2024.07.25

Kelly Douglas  
AICP Senior Planner  
City of Steamboat Springs  
PO Box 775088  
Steamboat Springs, CO 80477

**RE: DRT Review Comments DP**

Schematic Design, Ski Time Square Drive Turnaround & Complete Streets (2022)

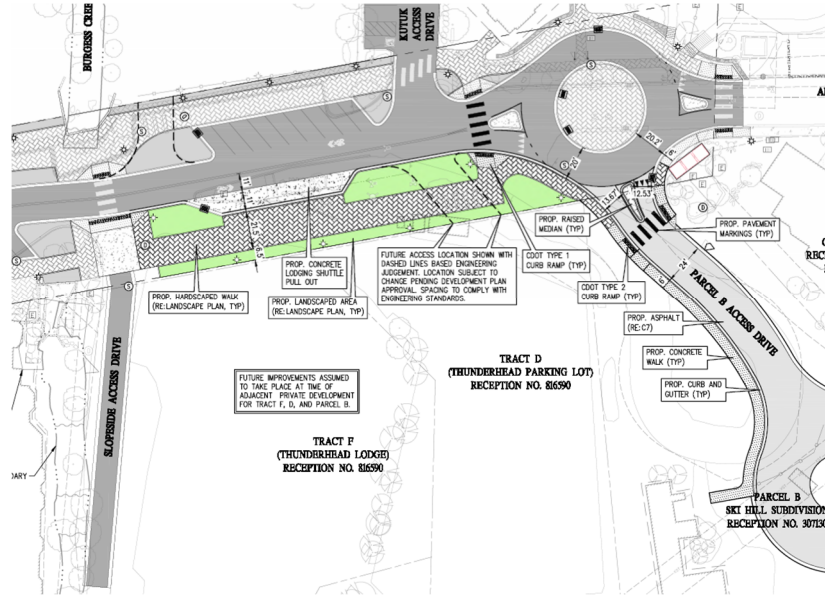
1. Please see the document titled "DRTMemo\_PL20240125\_URA Comments." - [Inserted below](#)
2. This review has been completed with a primary focus on the proposed project improvements in coordination with the Steamboat Springs Redevelopment Authority (SSRA) mountain plan area's past and current efforts.
3. The existing conditions should be updated to reflect the URA streetscape improvements currently under construction along Ski Time Square Drive. Alternatively, the applicant should provide an

exhibit showing how the streetscape improvements must be modified to accommodate the proposed development.

- a. Response: The plans have been modified to reflect this anticipated condition. Please refer to the revised drawings that also reflect the new streetscape along the property frontage including the introduction of angled parking.*
